**ZONING CHANGE REVIEW SHEET****CASE:** C814-2017-0001 – 425 W. Riverside PUD**Planning Commission Date:** February 13, 2018**ADDRESS:** 425 W. Riverside Drive**OWNER/APPLICANT:** Ronald A. Nelson and Molly Belle Properties (Ronald Nelson, Trustee)**AGENT:** Armbrust & Brown (Richard Suttle)/Stream Realty (David Blackbird)**ZONING FROM:** CS-1-V-NP      **TO:** PUD-NP**AREA:** 1.45 acres (63,162 sq. ft.)**SUMMARY STAFF RECOMMENDATION:**

Planning and Zoning staff recommends PUD zoning with conditions as referenced in the Land Use Plan.

EXHIBIT F - LAND USE PLAN-OPEN SPACE

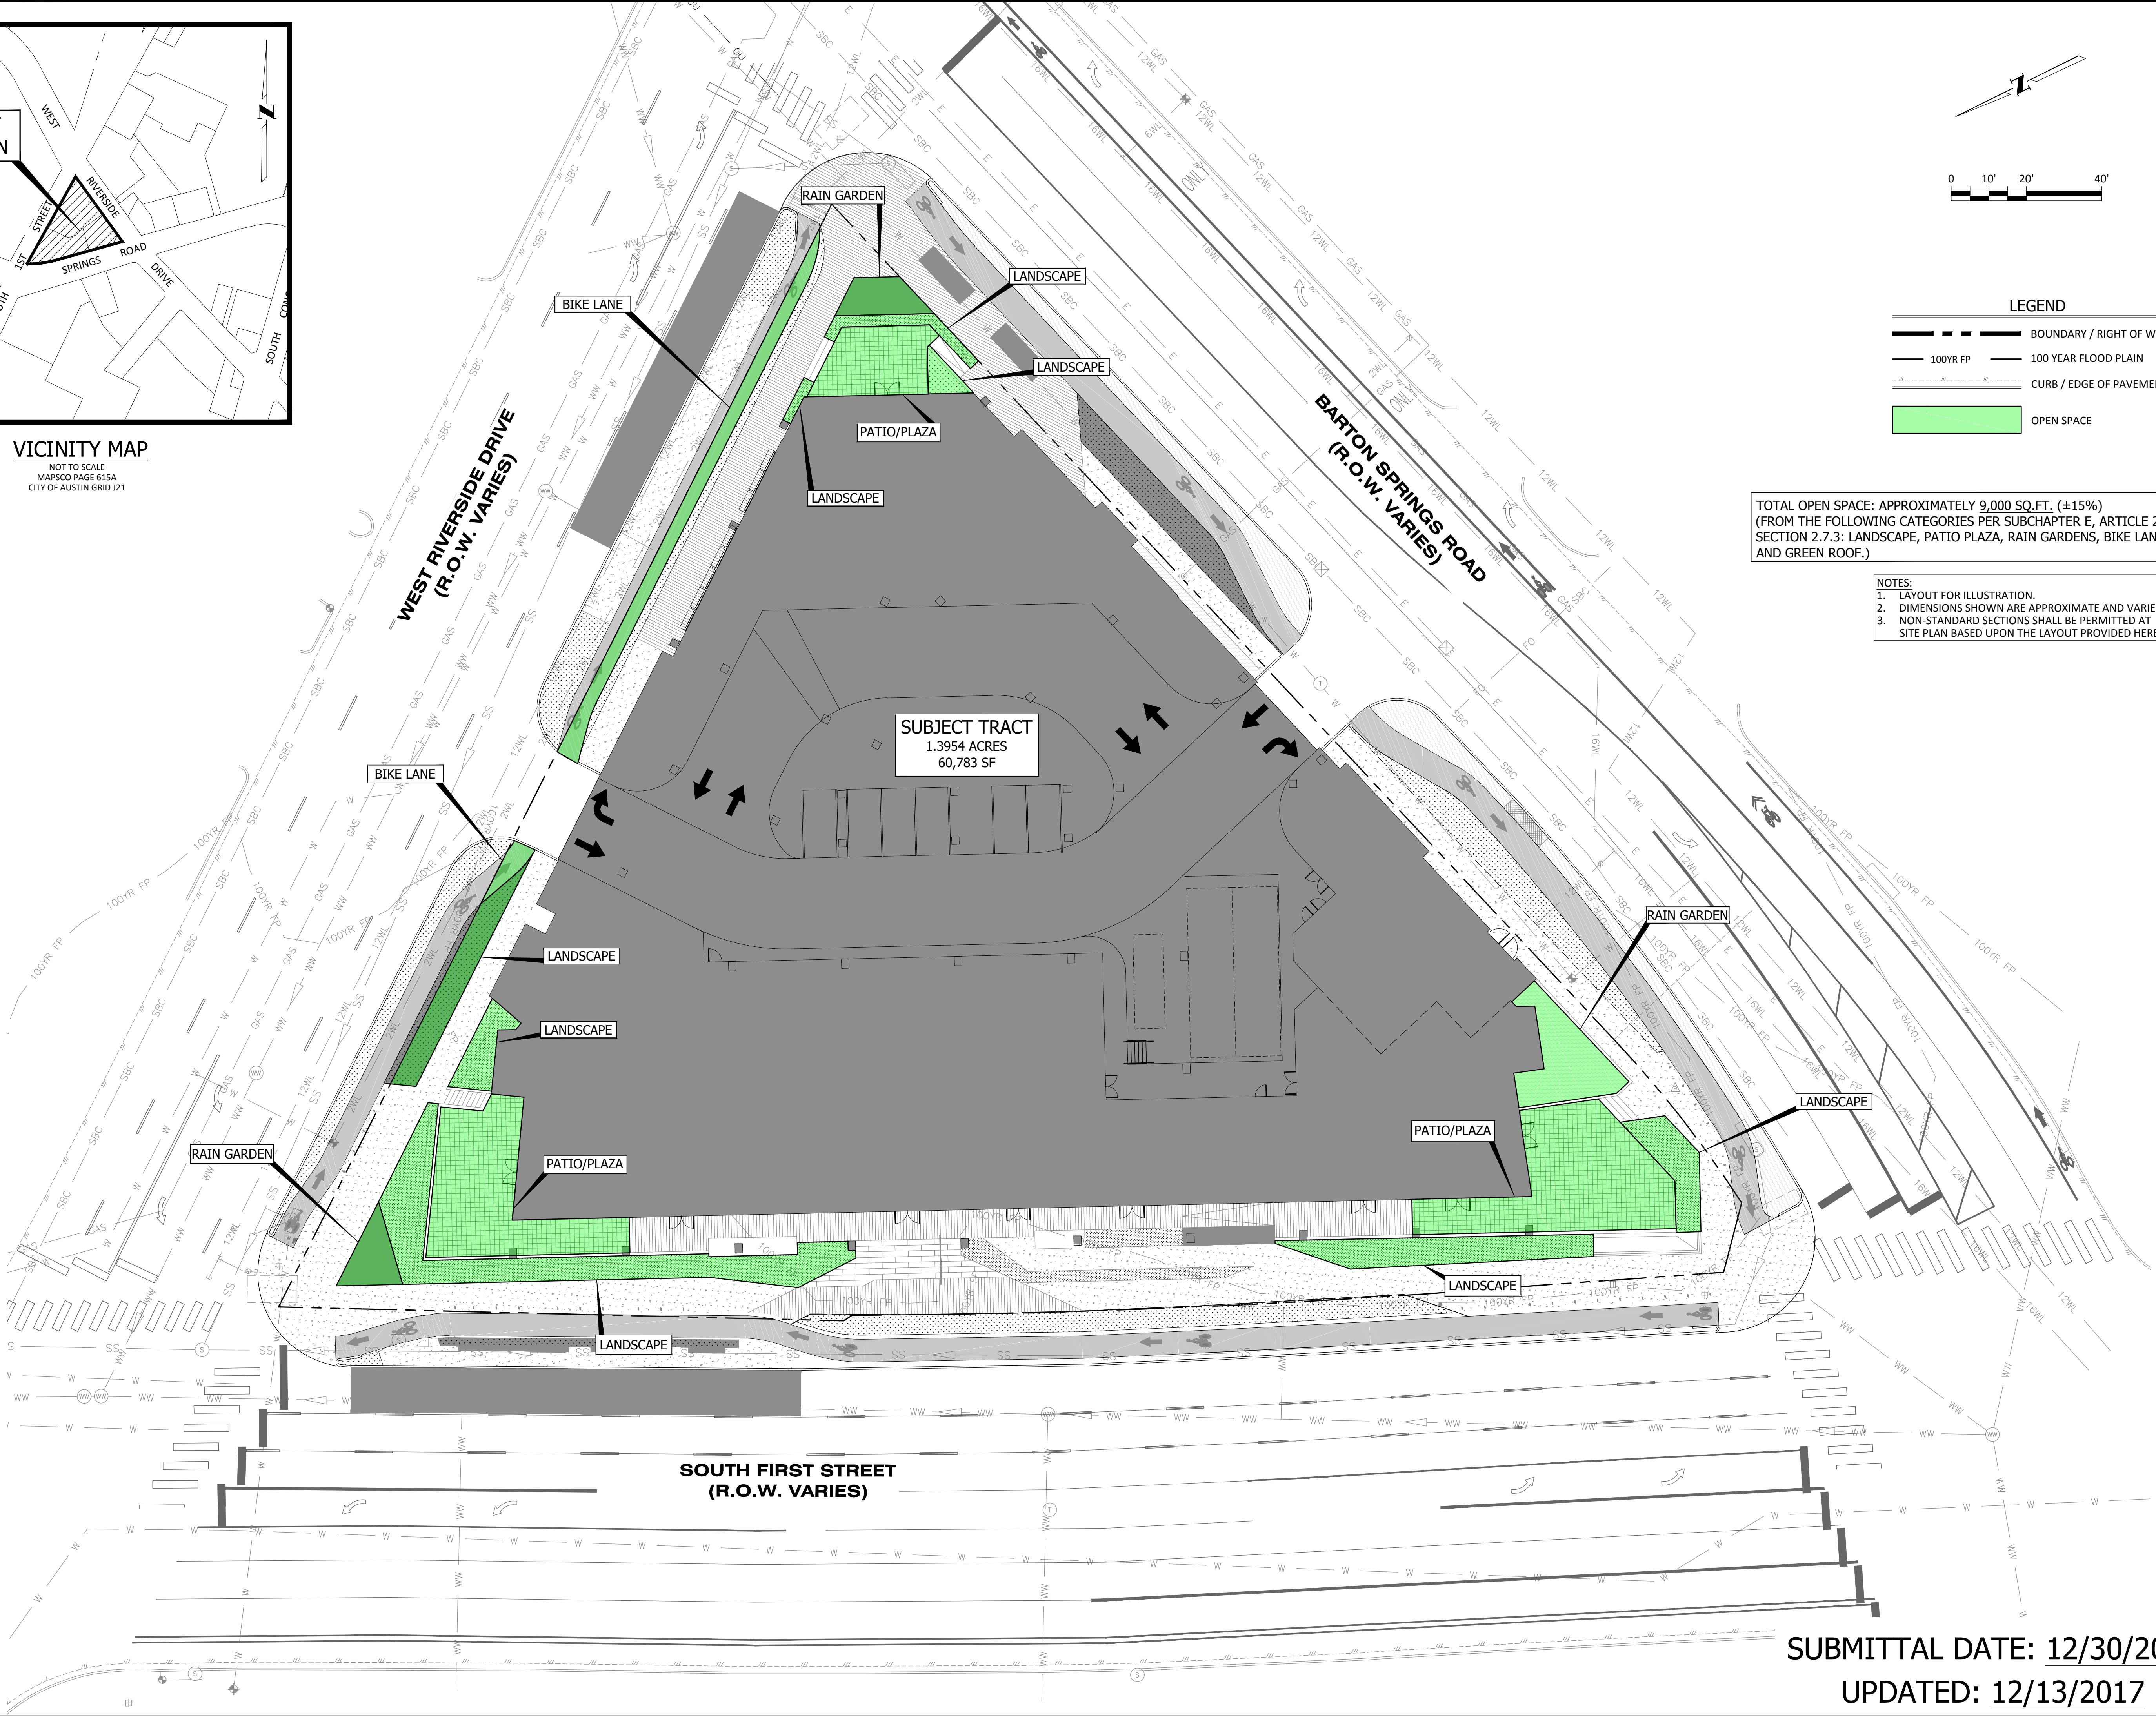
**U3: The proposed Open Spaces A, B, C, and D (green roof) are acceptable, as is the minimum commitment of 15% of the site. However, please prepare an open space exhibit that can be included with the PUD ordinance. (Something like the submitted exhibit can be used, but it currently says “for informational purposes only – Update 2”). This comment can be cleared informally.**

EXHIBIT - TREE PLANTING DETAILS

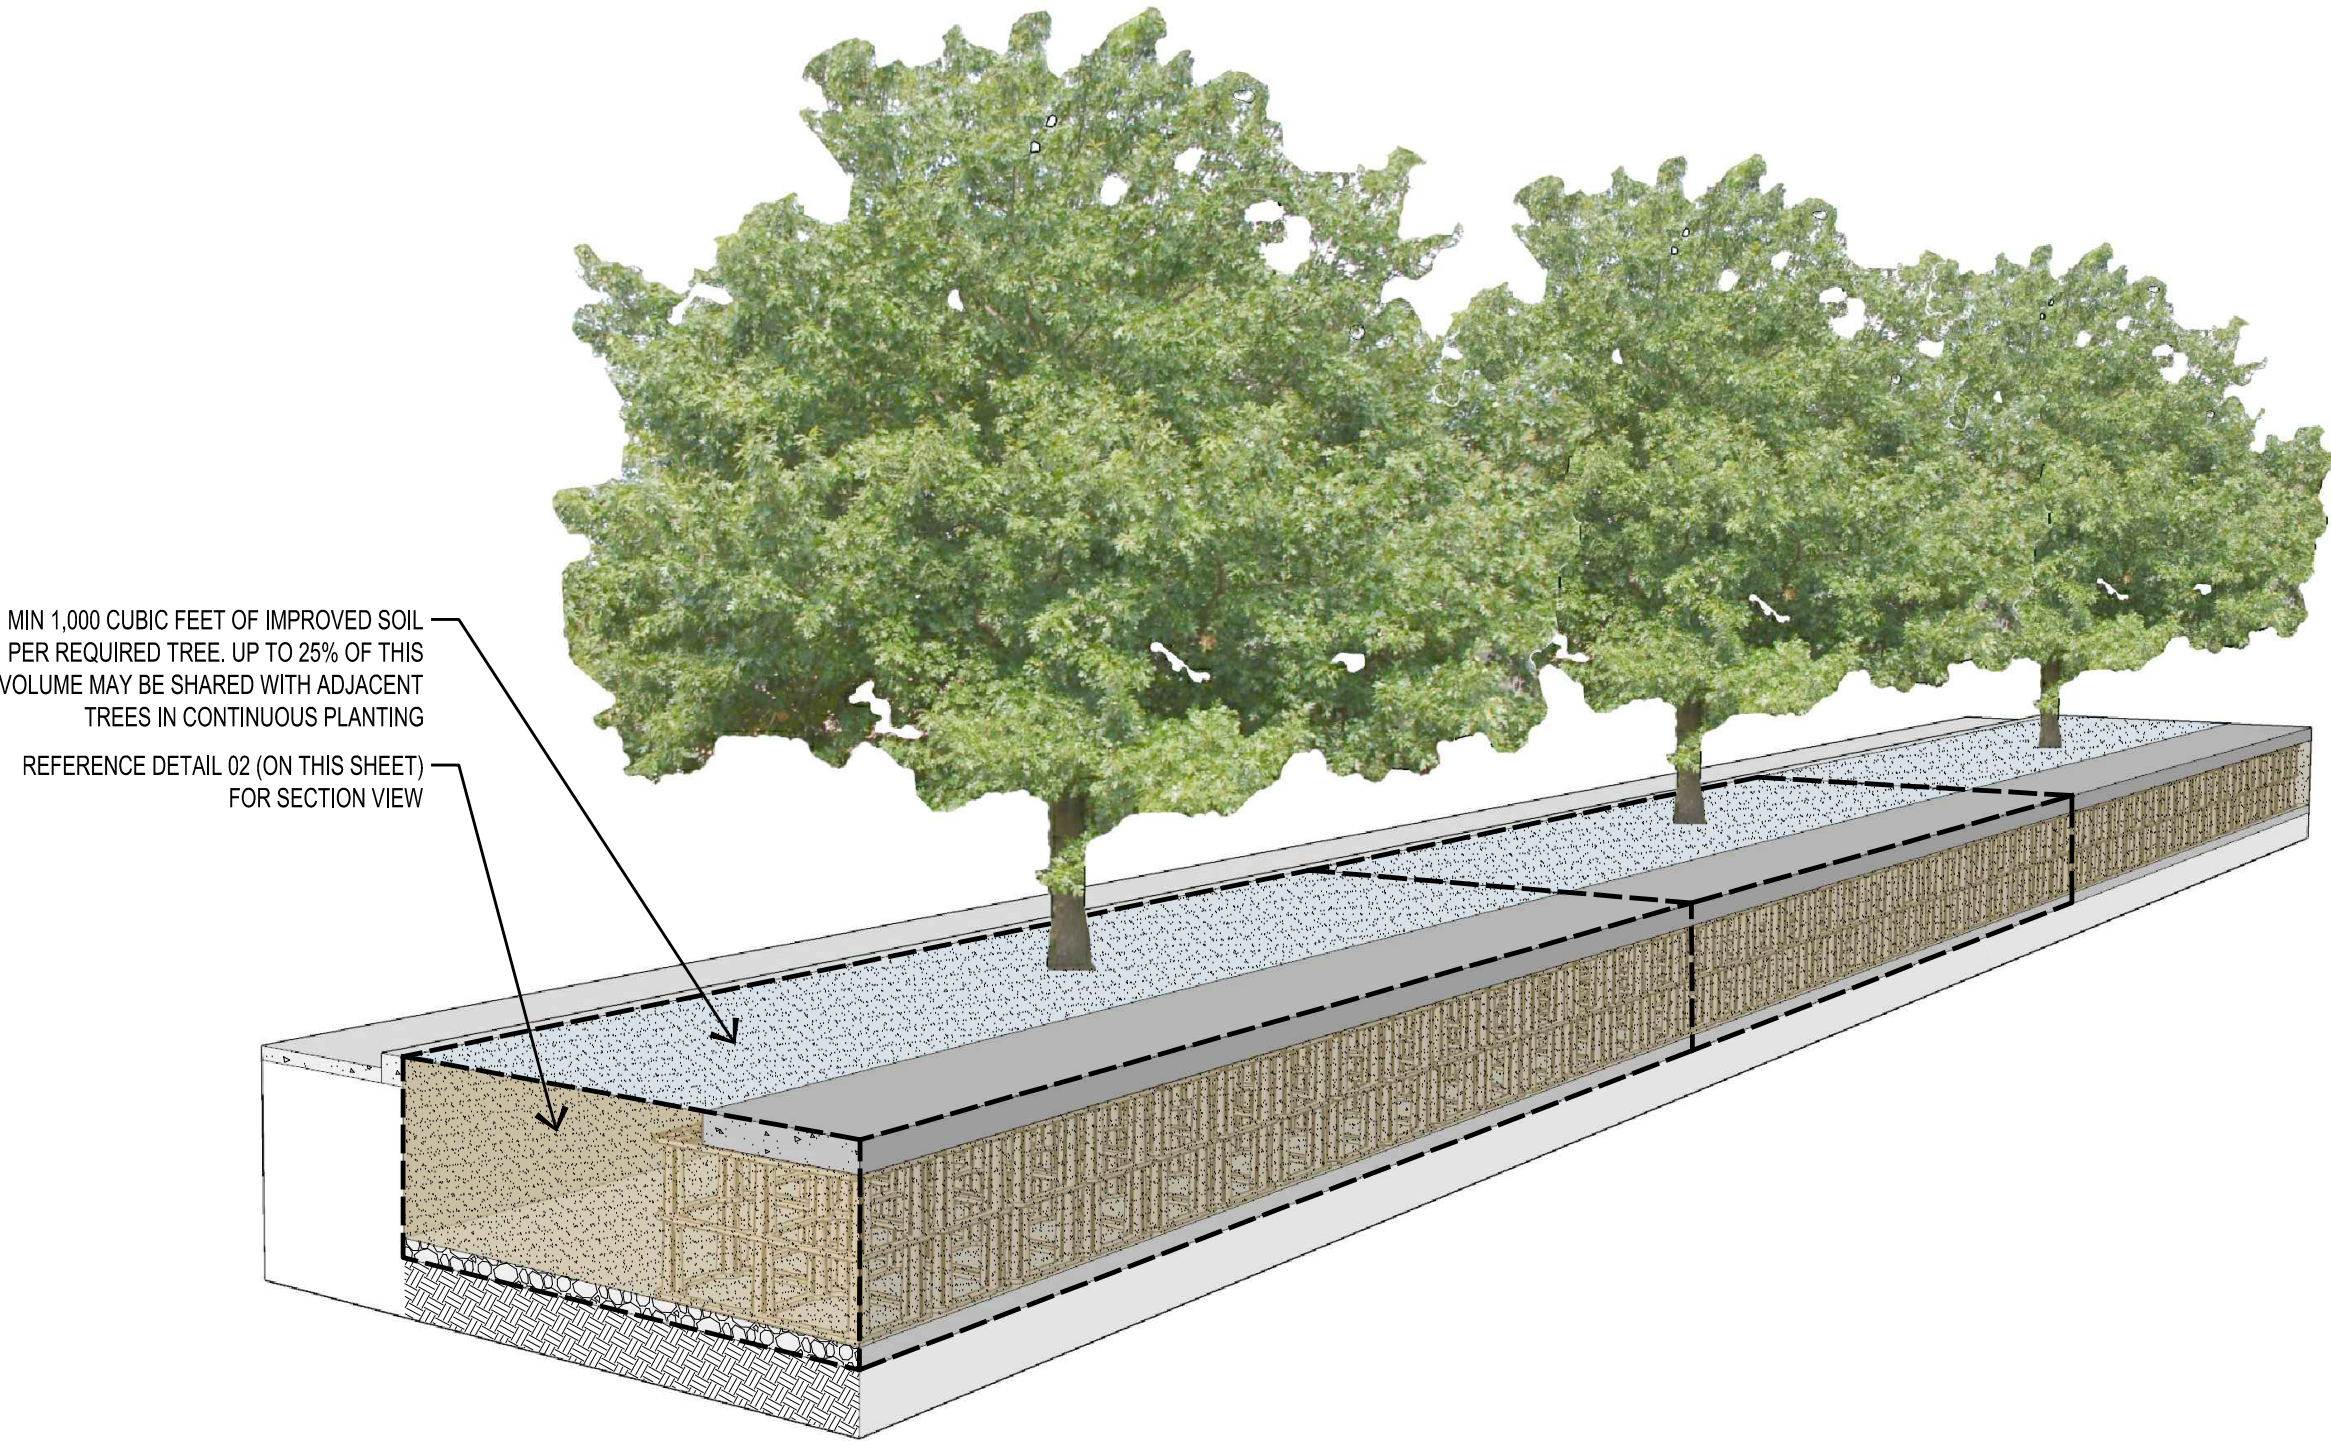
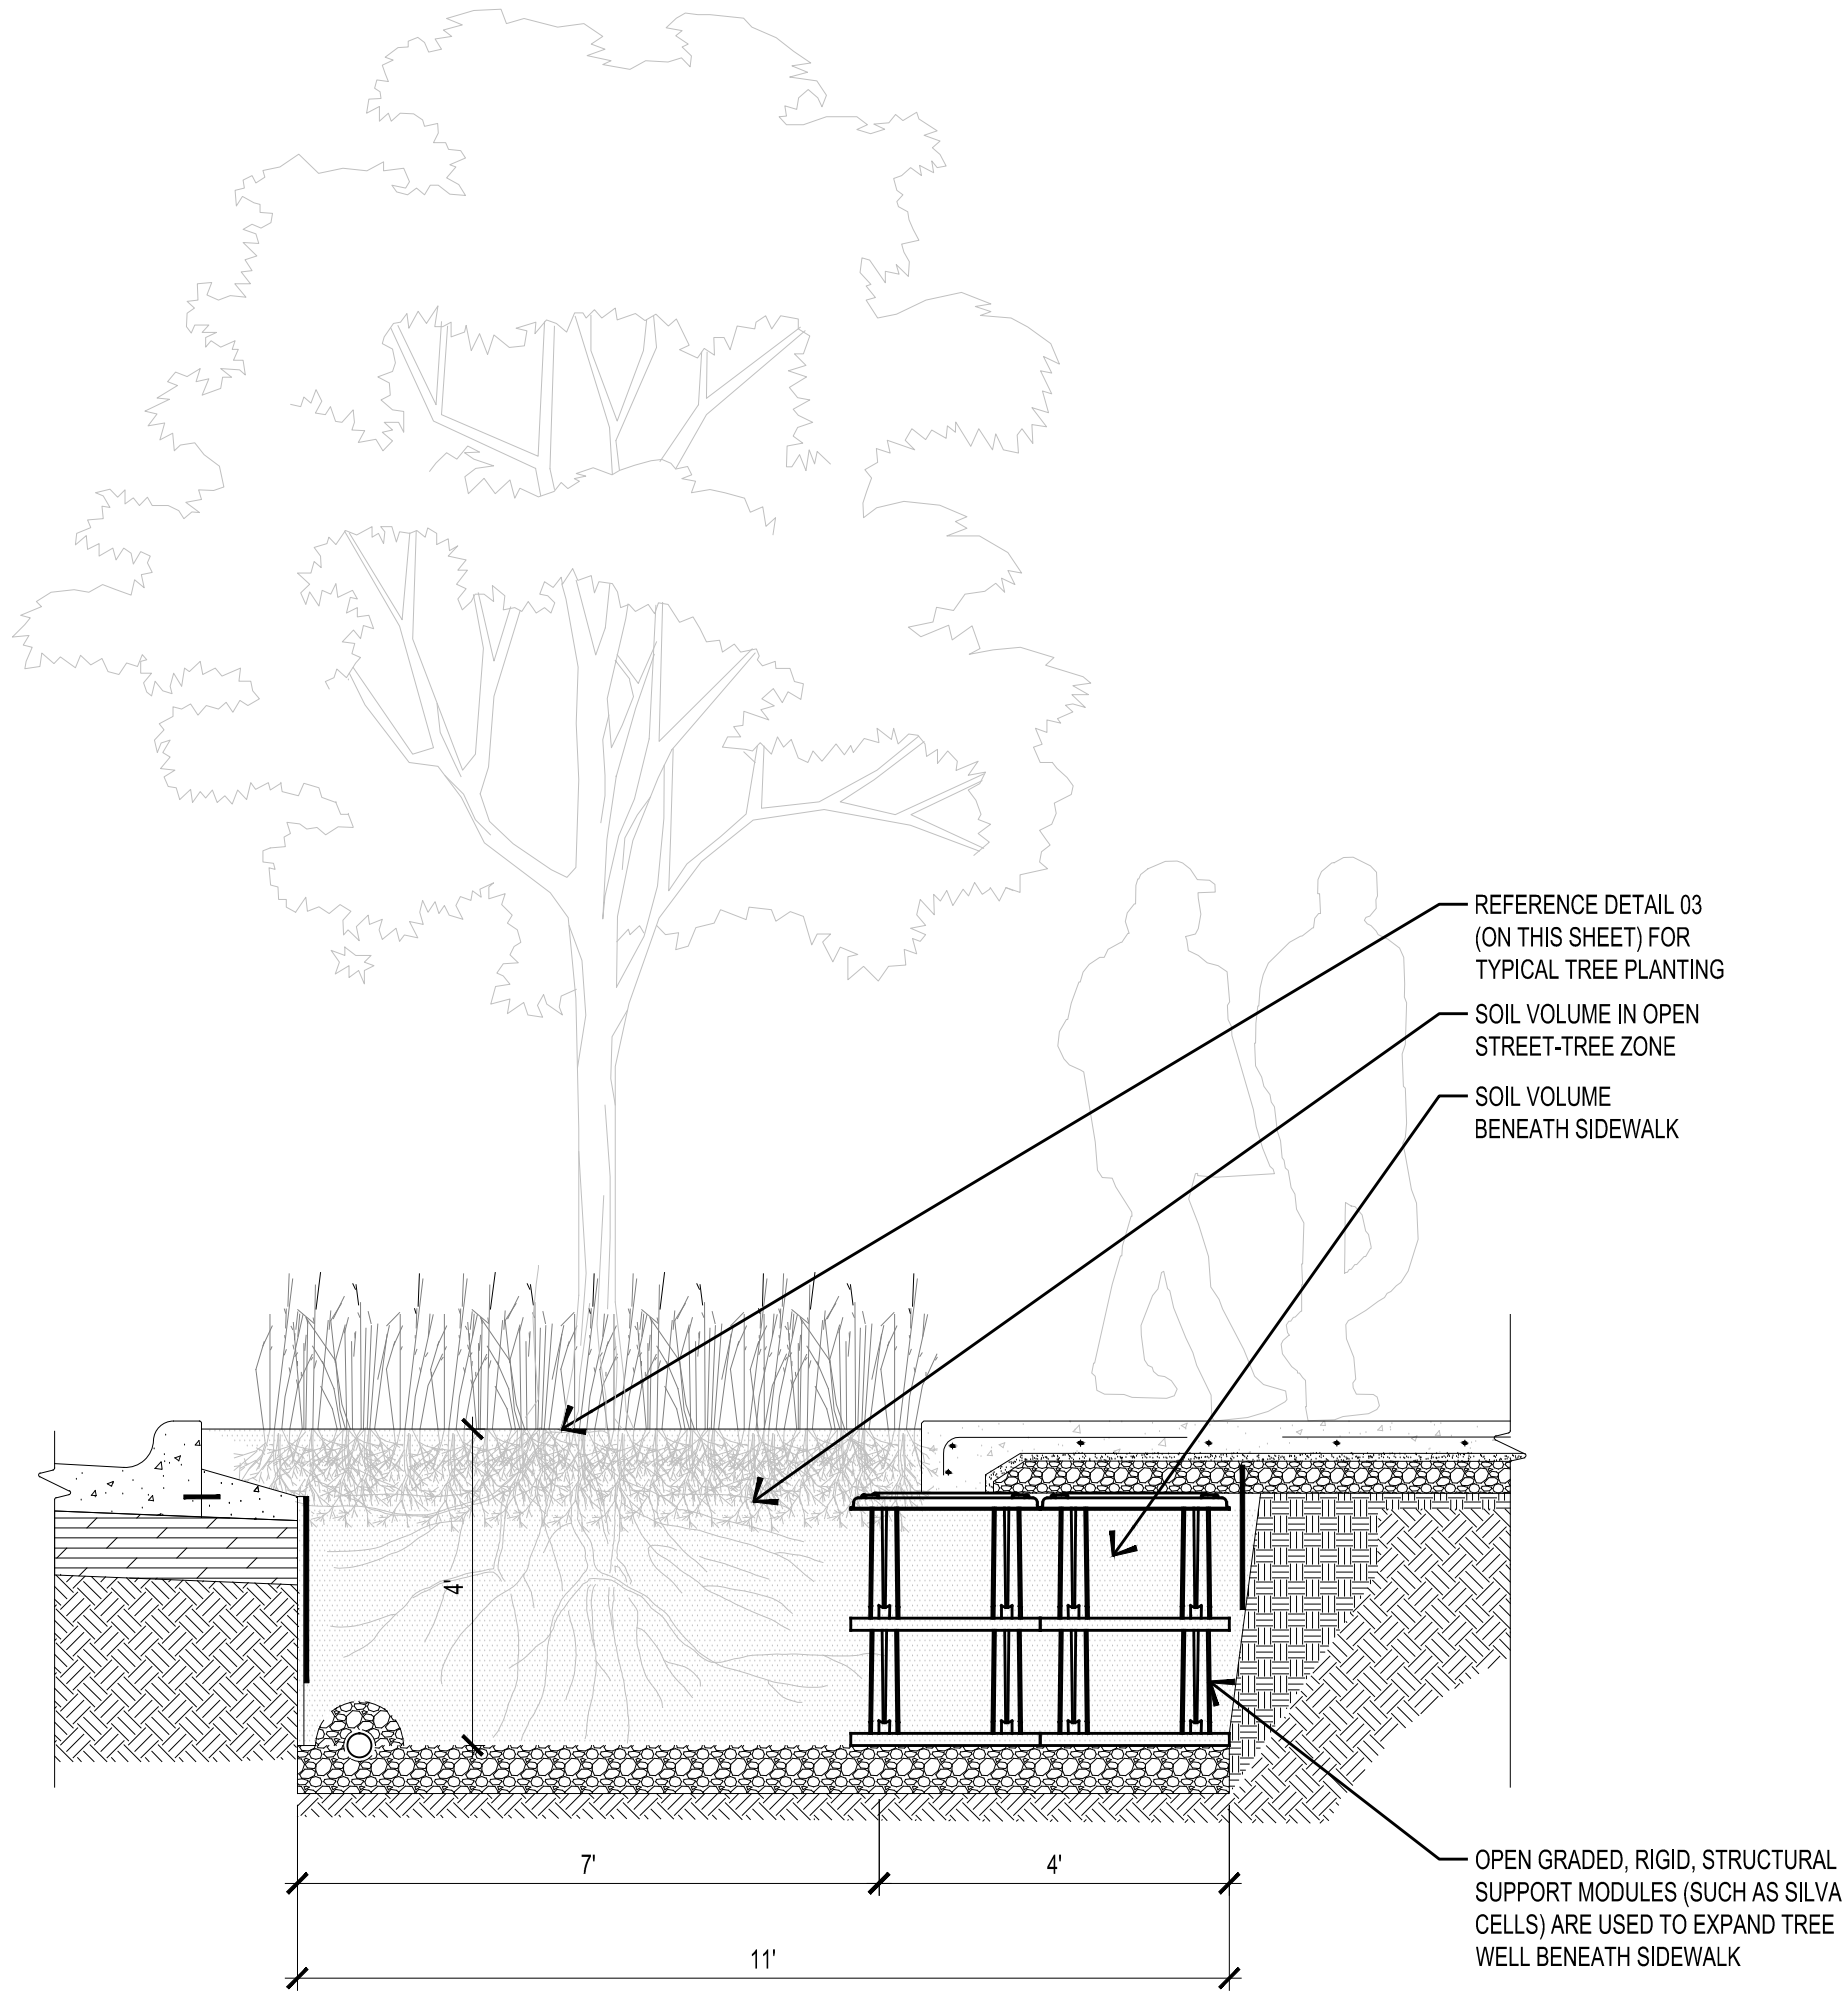
**UPDATE 3: Thank you for the additional information and calculations. While the PUD proposed planting of a larger diameter street tree could be considered for some environmental superiority, it would normally be a proposal to plant more trees than what would be required that would carry more weight. The PUD proposes a starting overall total frontage a bit less than the current code scenario. It also proposes an additional loss of frontage to accommodate greater options for alternative transportation with two new bus stops. These additional losses in total only allow the PUD scenario to plant one additional tree than the current code option. In this case, it will be the guarantee to plant a shade tree of higher quality that will carry some environmental superiority. To this point, because a multiplier has been used in both calculations to estimate loss due to utility conflicts and not on the ground verification staff is still not able to support the overall tree planting estimates.**

**Please also revise your soil commitments and notes to be consistent with the last update. These should include the larger 1540 CY soil volume required in locations other than ones with utility conflicts. In those cases where it is proven utility conflict then 1000 CY minimum is accepted with the use of soil cells. Comment pending.**

**UPDATE 3: Using the ANSI planting standards is acceptable but not superior, as these would be done anyway. Please explore additional standards for tree quality, to assure the best possible tree stock is available for the PUD. These could include presence of visible root flare a time of planting and no girdling roots. Comment pending.**
